APPEAL SUMMARY

Appeal ID: 15714	Project Address: 5515 SE 17th Ave
Hearing Date: 8/23/17	Appellant Name: Zac Horton
Case No.: B-001	Appellant Phone: 503-484-9654
Appeal Type: Building	Plans Examiner/Inspector: Renay Radtke-Butts
Project Type: commercial	Stories: 3 Occupancy: R-2 Construction Type: V-B
Building/Business Name:	Fire Sprinklers: Yes - throughout
Appeal Involves: Erection of a new structure	LUR or Permit Application No.: 16-284114-CO
Plan Submitted Option: pdf [File 1]	Proposed use: Apartments

Code Section 2014 OSSC Section 705.8.6.2 - Vertical exposure for buildings on separate lots.

SKETCH 'A'

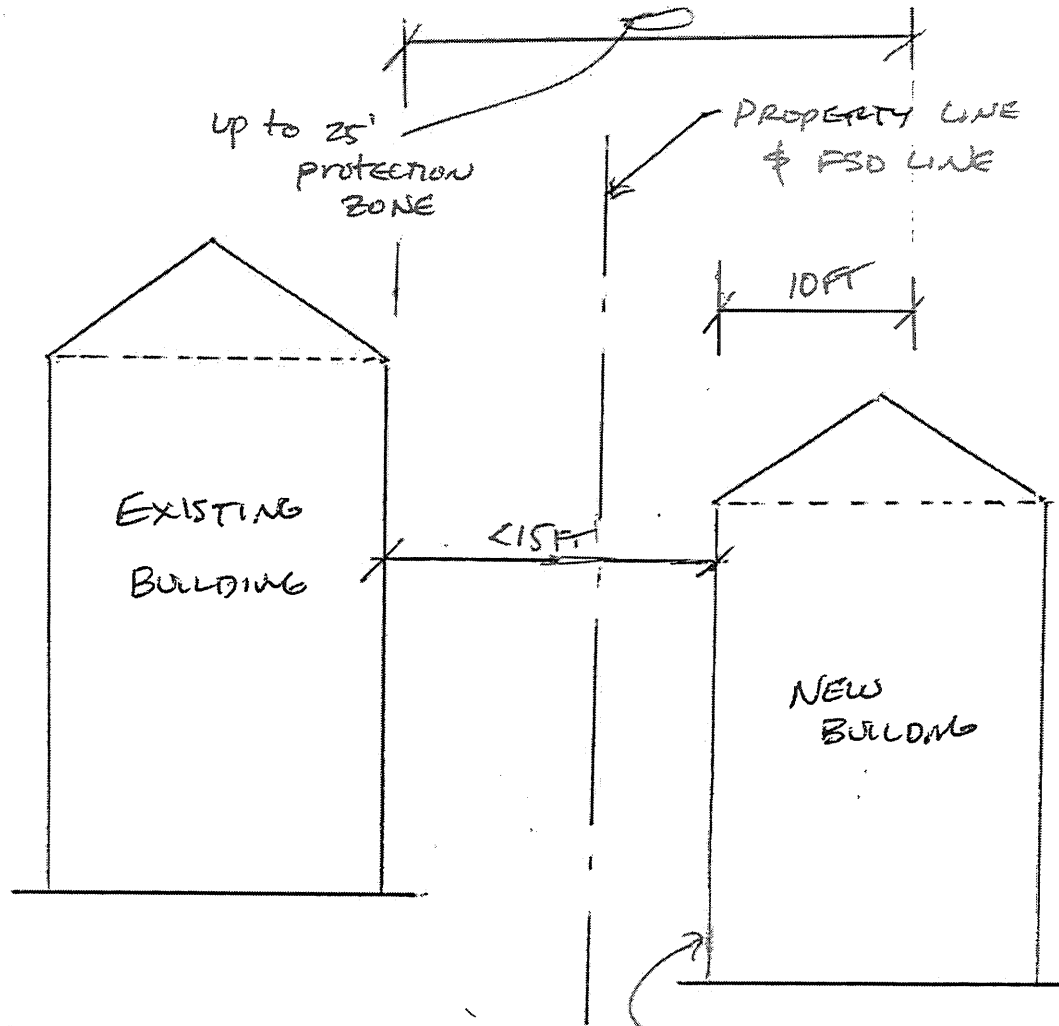
The difference in code interpretation between this office and City of Portland staff is related specifically as to where the 10 feet is measured from. Sketches have been provided to illustrate both cases.

Currently, City of Portland staff is interpreting the distance to begin from the new building wall, while we interpret it to be measured from the wall of the existing building wall.

The language of the code is in our opinion clear that in this situation the 10 feet is to be measured from the existing building "10 feet from the exterior wall facing the new building"... See Sketch 'A'. This is a reasonable interpretation, as it ensures that taller building is protected by the new building roof assembly when it is within 10 ft. of the lower roof.

10 feet from the EXTERIOR
Wall facing the NEW
BUILDING.

EMERU INTERP.

Point of origin of ten foot measurement for determination of roof protection due to vertical exposure for buildings on separate lots: Denied. Proposal does not provide equivalent Fire / Life Safety protection.

City staff is interpreting the 10 feet to be measured from the new building wall. See Sketch 'B'. This is counter to the propose of the code in the following ways, which is generally intended in this case

to protect the adjacent building wall from fire penetrating the roof of the new lower structure. If interpreted to be measured from the new lower building, this could result in a case where the roof of the lower building could be required to have a protection that is at its furthest 25 ft. from the adjacent other structure. This is a common and consistent theme (5 ft separation distance) throughout the OSSC. It is also unreasonable to consider that the State would require a 1-hour protection up to 25 ft.

CITY OF PORTLAND INTERP.

IF ONE IS TO INTERP
THIS WAY AS WHERE
TO BEGIN MEASURING
THE 10' DISTANCE.
